PROTEST- PETITION

PETITION FOR TIME EXTENSION, CHANGE, TEMPORARY URGENT CHANGE OR TRANSFER ON

I (We) have carefully read the notice (state name): NOTICE OF PETITION, REQUESTING CHANGES IN WATER RIGHTS OF THE DEPARTMENT OF WATER RESOURCES AND U.S. BUREAU OF RECLAMATION FOR THE CALIFORNIA WATERFIX PROJECT, dated October 30, 2015

ON BEHALF OF: Contra Costa Water District (CCWD)

Figure 2-1. Drinking Water Intakes in the Delta.

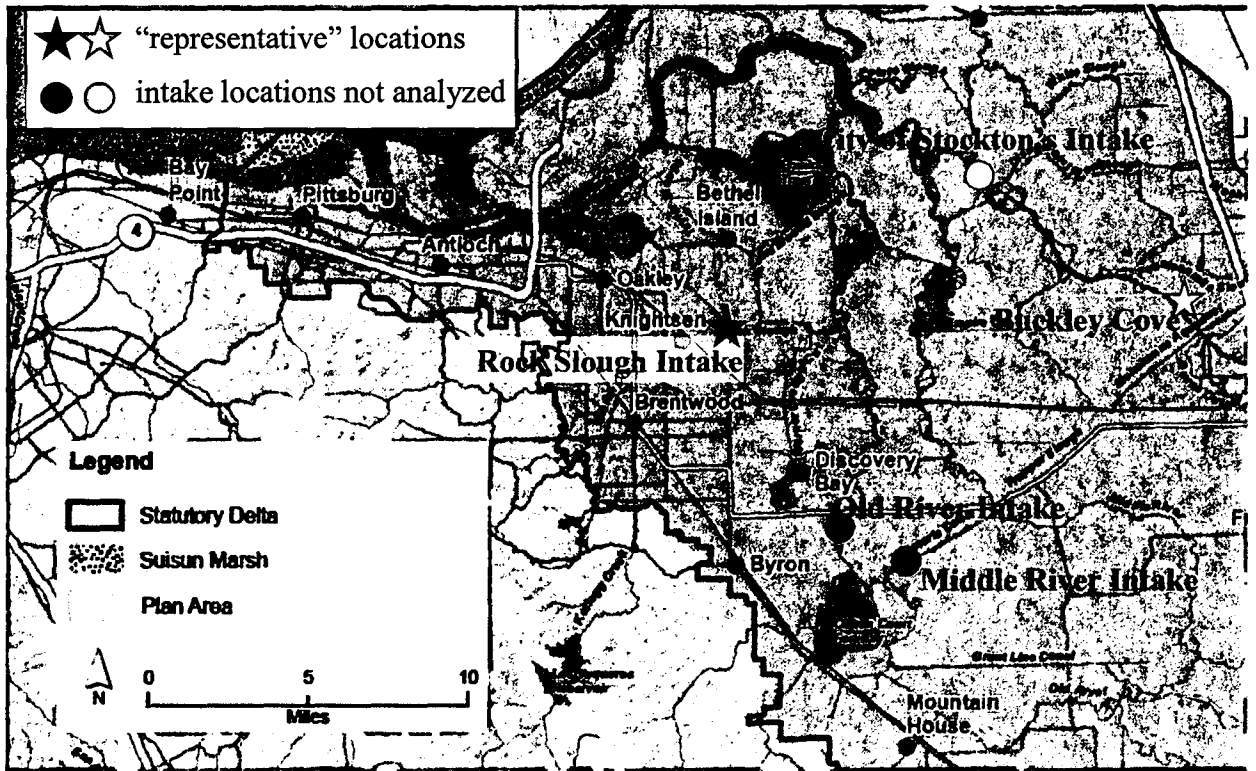
The BDCP Draft EIR/EIS inappropriately assumes that water quality at one location is representative of other locations, stating “[f]or municipal intakes located in the Delta interior, assessment locations at Contra Costa Pumping Plant No. 1 and Rock Slough are taken as representative of Contra Costa’s intakes at Rock Slough, Old River and Victoria Canal, and the assessment location at Buckley Cove is taken as representative of the City of Stockton’s intake on the San Joaquin River.” BDCP Draft EIR/EIS, Chap. 8 at pp. 8-149 and 8-162. This assumption is unreasonable. The actual intakes and their “representative” locations are up to 17 river miles apart (Figure 2-1). Hydrodynamic and water quality conditions vary widely within the Delta; indeed, it is the difference in salinity at different locations in the Delta interior that drove CCWD’s construction of its Old River intake and Middle River intake on Victoria Canal (collectively “Old and Middle River intakes”). Even intakes that are relatively close together such as CCWD’s Old and Middle River intakes have very different water quality because of the complexity of the hydrodynamics in the Delta (CCWD and Reclamation, 2006, Exhibit ES-2 at p. ES-5).

In fact, the differences in the quality of water at the “representative” sites in comparison to the actual intake locations were readily available to the BDCP consultants because the modeling that was used as the basis for the BDCP Draft EIR/EIS analysis includes results for water quality constituents at both the “representative” sites and at the actual intake locations. This modeling was provided by the DWR to CCWD in 2013 (DWR, 2013b). Plots of salinity variation in time at each location illustrate that the “representative” sites are, in fact, not representative of the actual intake sites. For instance, in the No Action Alternative, the salinity at Buckley Cove is dramatically different than the salinity at the City of Stockton’s intake (Figure 2-2). Similarly, in the No Action Alternative, salinity at the Rock Slough intake would at times be up to 800 microsiemens per centimeter greater than salinity at the Middle River intake; while at other times, salinity at the Middle River intake would be up to 200 microsiemens per centimeter greater than at the Rock Slough intake (Figure 2-3); neither the seasonal pattern nor the annual maximum and minimum values of salinity coincide temporally at these sites. Given the differences in salinity under the No Action Alternative between the “representative” sites and the actual intake locations,

it is not appropriate to use the “representative” sites to assess impacts at drinking water intakes when modeling results for the actual intake sites are readily available.

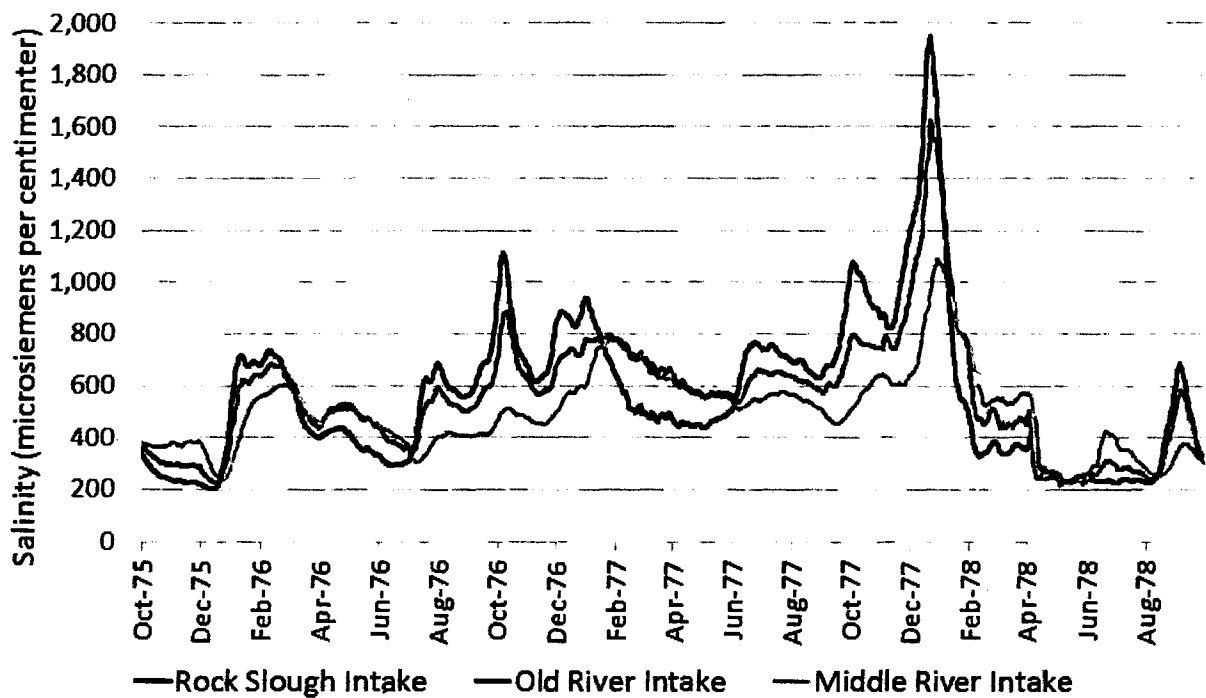
The differences in the quality of water at different locations in the Delta interior is partially due to the difference in the source of the water. For instance, some locations within the Delta interior are dominated by water that originated on the Sacramento River, while other locations are dominated by water from the San Joaquin River and still other locations are dominated by water from the Bay; the magnitude of local agricultural drainage also varies from place to place. The mixture varies spatially and temporally as river flows and tidal dynamics change throughout the seasons and between years. The modeling that was used as the basis for the BDCP Draft EIR/EIS analysis (DWR, 2013b) calculates the fraction of water that originates from the upstream rivers and the downstream bay at both the “representative” sites and at the actual intake locations. Plots of the percentage of water at each location that entered the Delta from the Sacramento River water illustrate that the “representative” sites are, in fact, not representative of the actual intake sites because the makeup of the water at each location is dramatically different. For instance, Figure 2-4 shows that the location of the City of Stockton’s intake often receives greater than 70% of its water from the Sacramento River, while Buckley Cove seldom receives any water from the Sacramento River.

Since all of the BDCP alternatives propose either to divert Sacramento River water before it enters the central Delta (Alternatives 1 through 8) or to construct numerous barriers that would alter the mixing of river and bay waters (Alternative 9), the BDCP would impact the mixture of water at all locations within the interior Delta. Because of the complicated nature of the movement and mixing of waters within the Delta, the impact would vary by location. For this reason, it is not appropriate for the BDCP Draft EIR/EIS to use “representative” sites when information at actual intakes sites is readily available.

Figure 2-5. Impact to CCWD’s delivered water quality

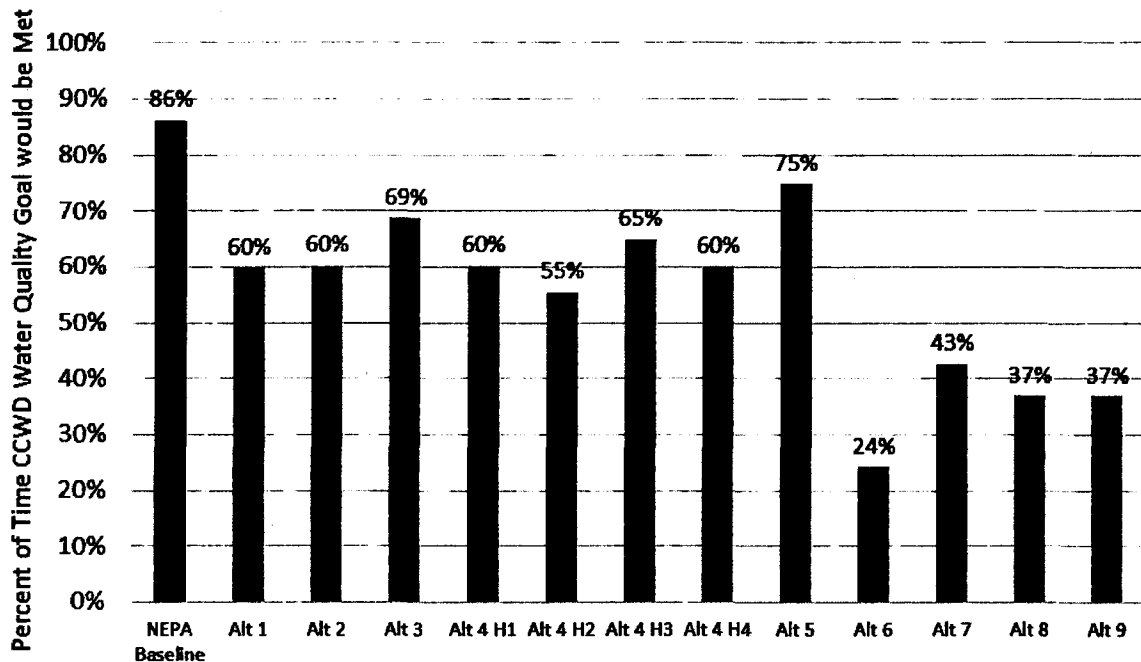
As illustrated in Figure 2-5, the percent of the time that CCWD could meet its water quality goal of 65 mg/L chloride concentration would be reduced in every alternative in comparison to the NEPA baseline.¹⁸ For instance, CCWD would be able to meet its water quality delivery goal 86% of the time under the No Action Alternative, but under Alternative 4 the delivery goal would be met only between 55% and 65% of the time, depending on the operational scenario (H1 through H4).

Figure 2-6. Impacts to Los Vaqueros Reservoir illustrated from modeling performed as the basis for BDCP Draft EIR/EIS.

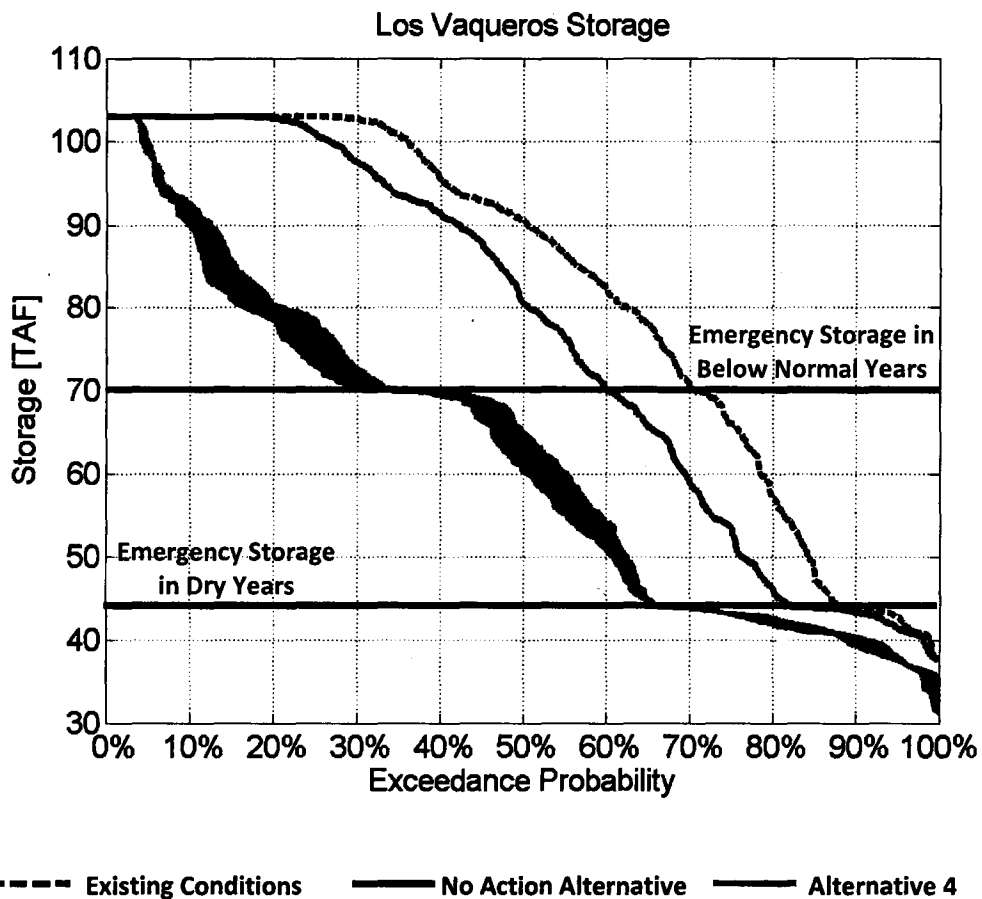
As shown in Figure 2-6, the DWR Preferred Alternative, Alternative 4, would result in significant reductions in storage in Los Vaqueros Reservoir compared to the existing conditions and the No Action Alternative. Without the BDCP, Los Vaqueros Reservoir would be at maximum storage capacity 30% of the time under existing conditions and 20% of the time under the No Action Alternative; with the DWR Preferred Alternative, Los Vaqueros Reservoir would be at maximum storage²⁵ only 4% of the time. Furthermore, without the BDCP, Los Vaqueros Reservoir would remain above the emergency storage level designated for below normal years (70 thousand acre-feet) 70% of the time under existing conditions and 60% of the time under the No Action Alternative; however, the DWR Preferred Alternative would reduce storage such that the reservoir would be above this level only 29% to 34% of the time, depending on the outcome of the BDCP "decision tree" process. The BDCP modeling clearly shows that while other future conditions that may occur without the BDCP, such as climate change and sea level rise, do have an impact on the storage in CCWD's Los Vaqueros Reservoir,²⁶ the BDCP would have a much more significant impact.²⁷

²⁶ As evidenced by comparison of the existing conditions and No Action Alternative in Figure 2-6.

²⁷ As evidenced by comparison of the No Action Alternative and Alternative 4 in Figure 2-6.

Figure 2-7. Impacts to Los Vaqueros Reservoir based on refined modeling, taking into account biases identified by DWR and correcting the storage capacity of Los Vaqueros Reservoir.

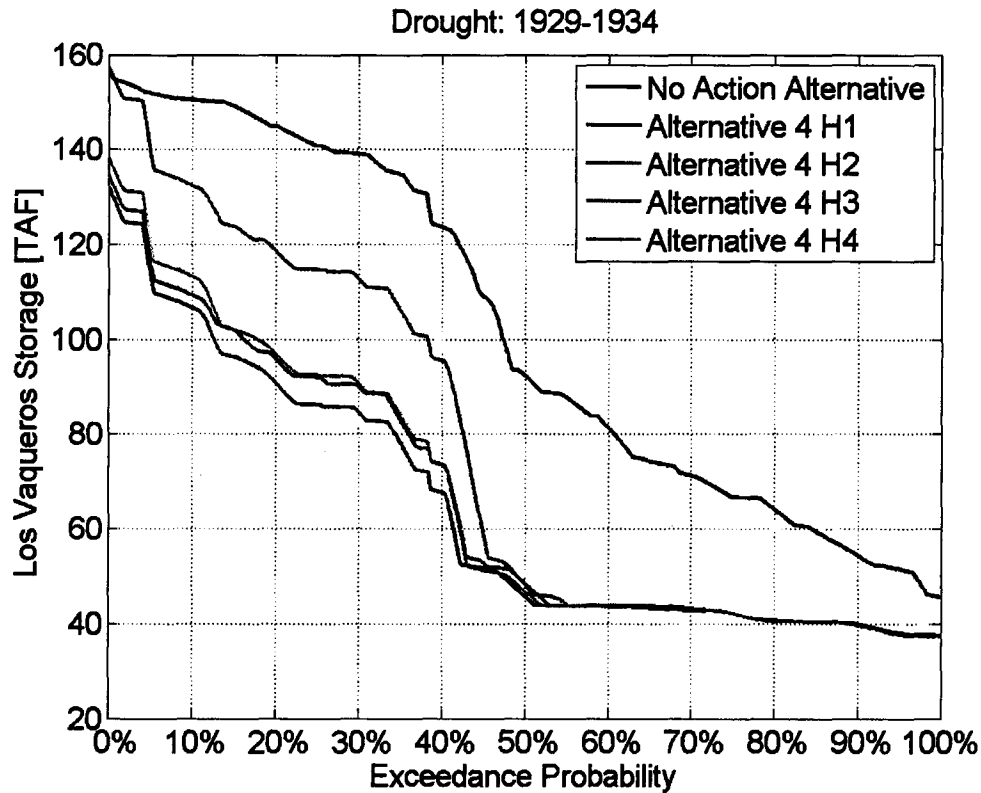
The volume of water in storage in Los Vaqueros Reservoir is greatly reduced by BDCP Alternative 4 for all possible outcomes of the decision tree (i.e. operational scenarios H1 through H4) during a potential six-year drought. Data source: modeling performed by CCWD following the suggestions of staff at DWR.

Figure 2-6 and Figure 2-7 illustrate how the DWR Preferred Alternative, Alternative 4, would impact storage in Los Vaqueros Reservoir; similar impacts would be likely to occur under all BDCP alternatives that have significant impacts on chloride concentration at CCWD’s intakes, which includes all of the action alternatives. BDCP Draft EIR/EIS, Executive Summary, Table ES-9 at p. ES-64.

Figure 2-8. Percent of years when San Luis Reservoir drops below the “low point” that creates water supply and water quality impacts for certain Central Valley Project contractors

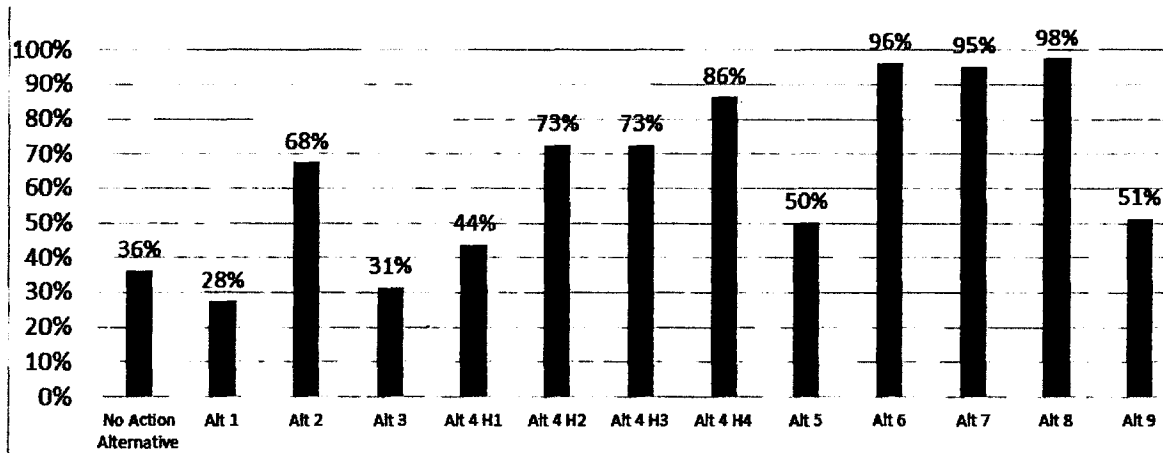
As described in Section 1.1.2, CCWD determined the percentage of time that the water level in San Luis Reservoir would drop below the “low point” by extracting relevant information from modeling that served as the basis for the BDCP Draft EIR/EIS analysis and that was provided to CCWD by DWR (DWR, 2013b). For all alternatives except for Alternatives 1 and 3, the BDCP would exacerbate the San Luis Reservoir low point problem (Figure 2-8). Under the DWR Preferred Project, Alternative 4, storage in San Luis Reservoir would drop below 300 thousand acre-feet in 44% to 86% of the years, depending on the outcome of the decision tree studies, as compared to 36% of the years under the No Action Alternative.

The BDCP would increase the percent of years that would experience impacts related to low storage levels in the San Luis Reservoir for alternatives 2, 4, 5, 6, 7, 8, and 9.

Figure 2-9. BDCP facilities (Alternative 4) with CCWD intakes and pipeline in the south Delta.

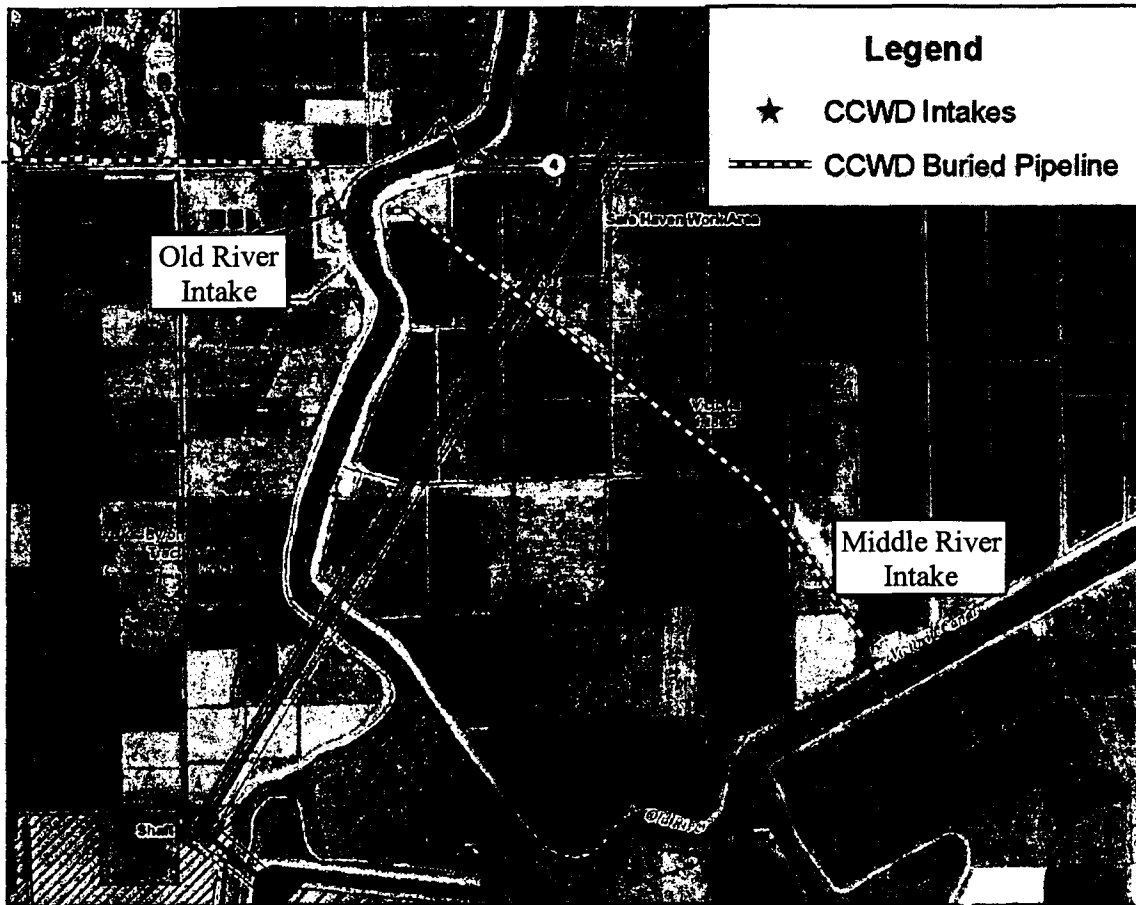
Construction of CM1 in Alternative 1A, 2A, 3, 4, 5, 6A, 7, and 8 would be likely to restrict access to CCWD's existing facilities. The tunnels would cross under the CCWD Middle River Pipeline in Victoria Island and under the Western Area Power Administration power line that was constructed for the Middle River intake. Figure 2-9 below shows CCWD's facilities superimposed on the BDCP facilities. BDCP Draft EIR/EIS, Chap. 3 Mapbook Figure M3-4 (Sheet 11 of 15), and Chap. 13, Mapbook Figure M13-4 (Sheet 6 of 8).

Construction work could interfere with CCWD's routine maintenance access to facilities along the tunnel alignment. Construction at Highway 4 may affect daily access to the Middle River intake and facilities there. Similarly, construction could impair emergency ingress and egress to the intake on the Victoria Island levee road.

Figure 3-2. Old and Middle River flow when HORB is closed

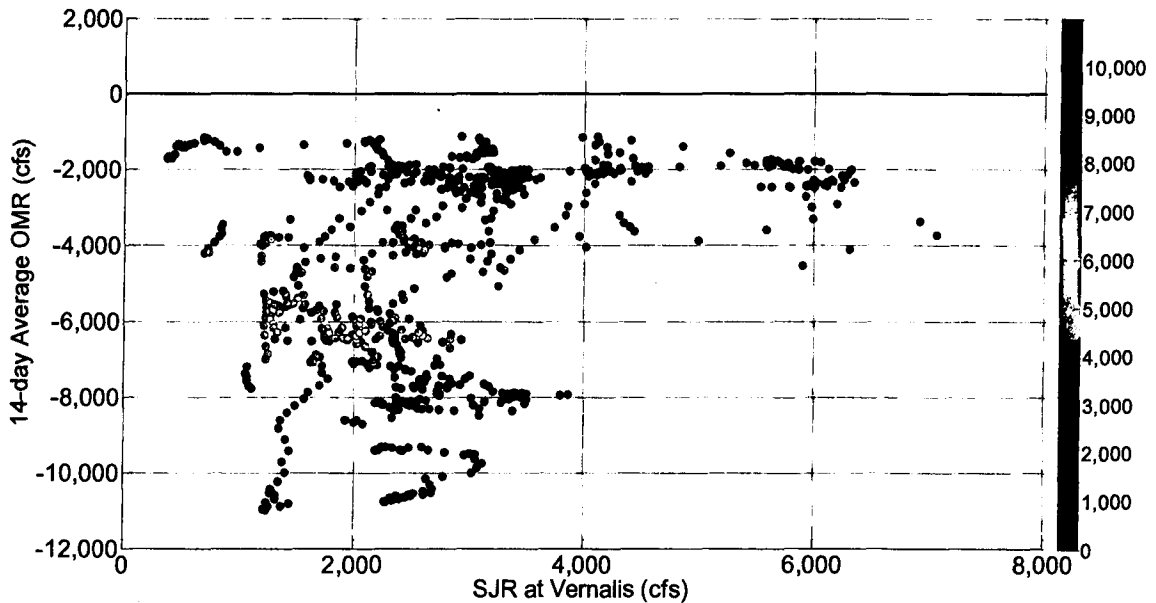
Closure of the HORB blocks flow in the San Joaquin River from entering Old River which, as discussed above, is the only source of positive OMR; closure of the HORB thus prevents OMR from being positive. As a result, the project description for OMR flow requirements is internally inconsistent with the project description for HORB operation in two-thirds of the analysis period.

This inconsistency is demonstrated by reviewing measurements of OMR flows at times when a barrier has been installed at the head of Old River in the past. Historically, a temporary barrier of rocks at the head of Old River has been constructed in the fall or spring¹. Review of OMR flows that were measured when the HORB was installed confirms that OMR is never positive with the HORB installed (Figure 3-2).

Pumping at the existing CVP and SWP export facilities in the south Delta (Jones and Banks, respectively) contributes to negative OMR – the greater the total pumping at the existing south Delta facilities, the more negative OMR (Figure 3-2). Limiting pumping at the south Delta facilities limits the negative OMR but cannot create positive OMR. Positive OMR can only occur with inflow from the San Joaquin River when the HORB is *not* installed.

Figure 3-3. Frequency of Excess Outflow in October

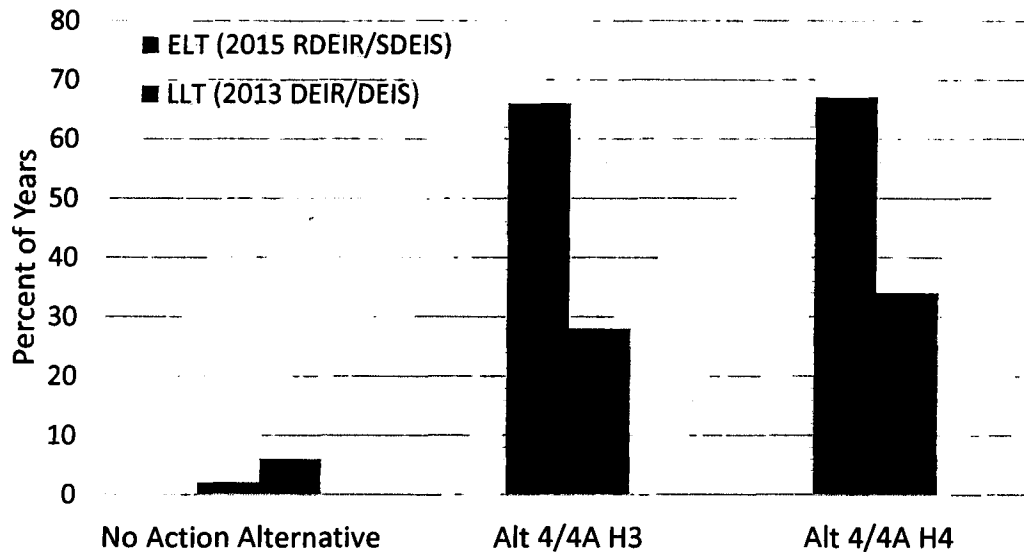
However, the BDCP modeling indicates that Delta outflow would exceed the amount necessary to meet minimum outflow requirements and salinity standards over 66% of the time in the early long term (ELT) for Alternatives 4/4A² H3 and H4 (Figure 3-3). In comparison, the No Action Alternative³ has excess Delta outflow in October only 2% of the time in the ELT.

The dramatic increase in the occurrence of excess flow under Alternatives 4/4A H3 and H4 in the ELT is not as substantial in the late long term (LLT) and is probably the cause for the different impact determinations between the ELT (as analyzed in the RDEIR/SDEIS) and the LLT (as analyzed in the 2013 BDCP Draft EIR/EIS). Although excess October Delta outflow occurs less often in the Alternative 4/4A LLT modeling than in the Alternative 4/4A ELT modeling, the frequency of occurrence in the LLT modeling is also unrealistic.

Figure 3-5. Excess Delta Outflow in the month of October during the Early Long Term biases the modeling results for multiple months

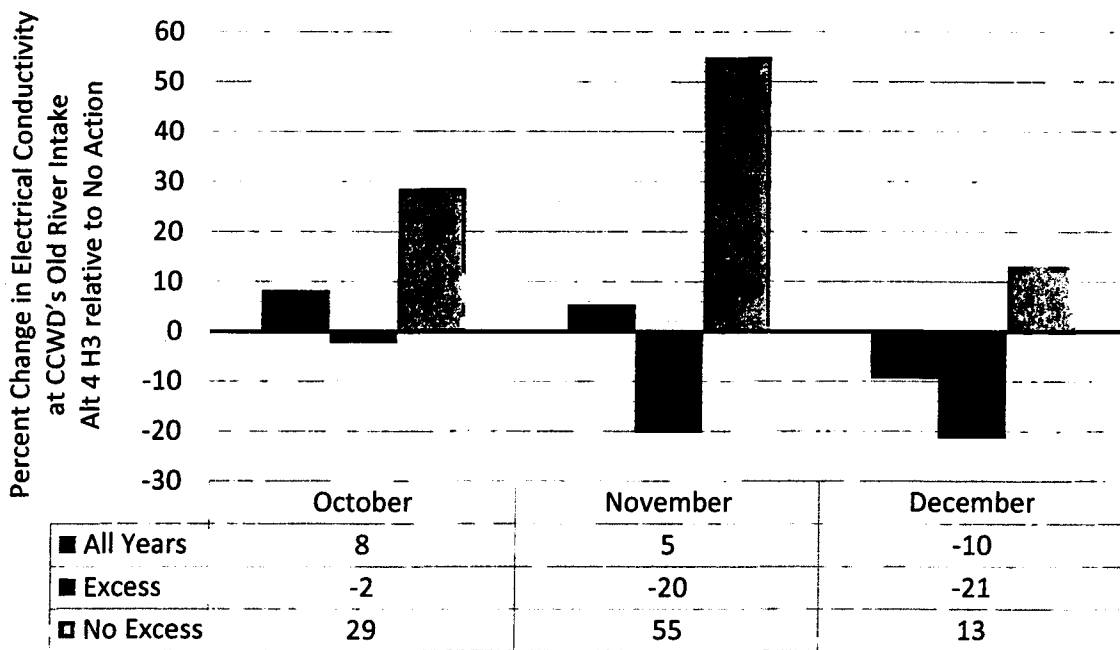
The unrealistic excess Delta outflow in October freshens the modeled interior Delta salinity for many months. This is illustrated in Figure 3-5, which shows that excess Delta outflow in October freshens the water at CCWD’s Old River Intake in October and that the freshening effect is maintained through December (blue bars in Figure 3-5). In contrast, during years without excess Delta outflow in October, Alternative 4/4A H3 increases the salinity at CCWD’s Old River Intake in October, November, and December (orange bars in Figure 3-5). Further, averaging salinity over all years (green bars in Figure 3-5) underestimates the impacts that would occur.

This discussion serves to show that the unrealistic assumption of excess Delta outflow results in a significant underestimation of salinity impacts as a result of the proposed project. Conversely, implementing and modeling an operations plan that corrects this unrealistic excess Delta outflow assumption would reveal greater salinity impacts due to the project.
